ANN ARBOR HISTORIC DISTRICT COMMISSION

Staff Report

ADDRESS: 517 West William Street, Application HDC14-077

APPLICATION: The applicant seeks HDC approval to install one 4' x 4' aluminum framed window in an exterior block masonry wall.

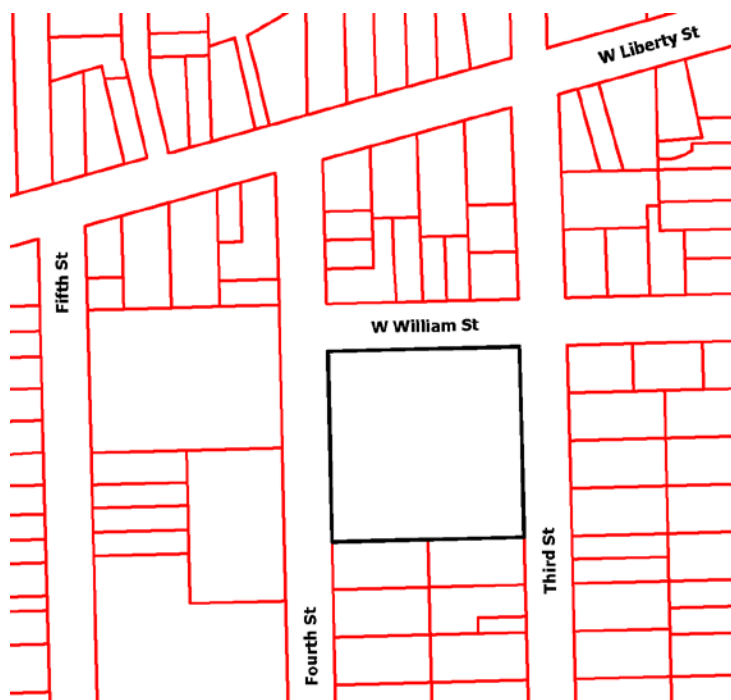
1. The portion of the building where the window is proposed to be installed, off Fourth Street, was added to the building in the 1940s as a service area for the Argus cafeteria. The wall is concrete block and does not contain character-defining features. The window to be installed is similar to one around the corner on the same addition. The application is very thorough and provides complete information on the installation.
2. Staff recommends approval. The design and placement of the window are appropriate. The window will not detract from any historic features of the building or the district.

I move that the Commission approve the application at 517-535 West William Street, a contributing property in the Old West Side Historic District, to install a window as proposed. The proposed work is compatible in exterior design, arrangement, texture, material and relationship to the rest of the building and the surrounding area and meets *The Secretary of the Interior's Standards for Rehabilitation and Guidelines for Rehabilitating Historic Buildings*, in particular standards 1, 2, and 9, and the guidelines for windows.
